**Petroleum and related products —
Precision of measurement methods
and results —**

**Part 1:
Determination of precision data in
relation to methods of test**

AMENDMENT 1

Reference number
ISO 4259-1:2017/Amd.1:2019(E)

Figure 1

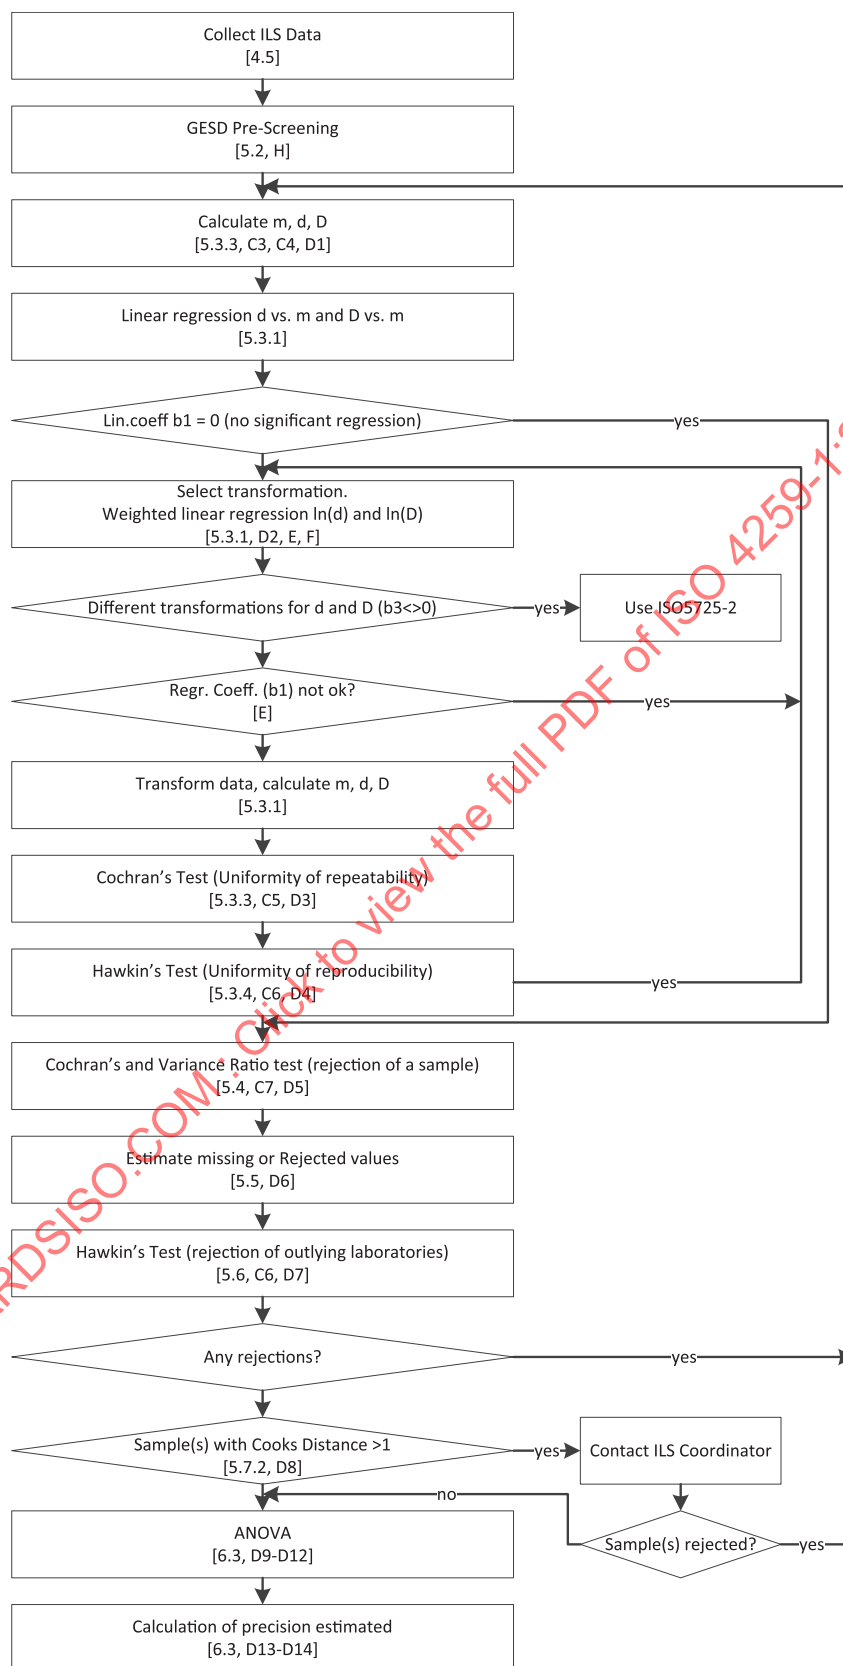
Replace the Figure with the following:
